Access Compliance Report Public Rights-of-Way (Curb Ramps)

Main Street: **DARWIN_AVE** Cross Street: **PACIFIC_ST** Location: **NW**

ADA ID: **RPRK211005182232** Ramp Type: **Type 1 - Perpendicular Diagonal Initial Pass/Fail: Fail** Overall Compliance: **No** Severity Score: **16**

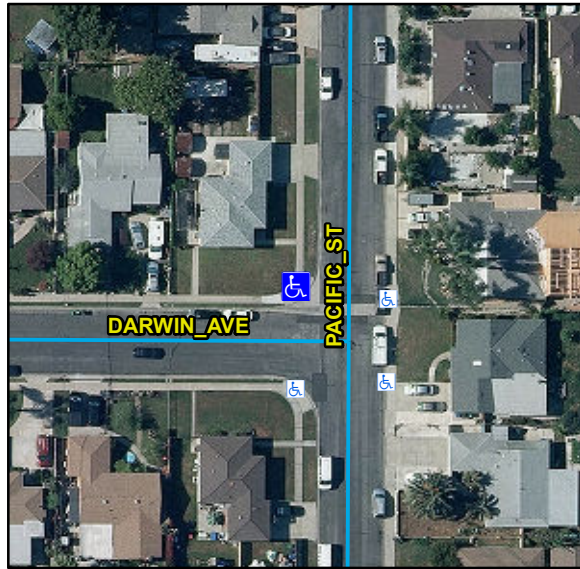
OC Std/PROW:
R304.2.2, R304.5.3, STD 1115

Possible Solutions:
Remove & Replace Curb Ramp With Two New Directional Ramps or Equivalent.
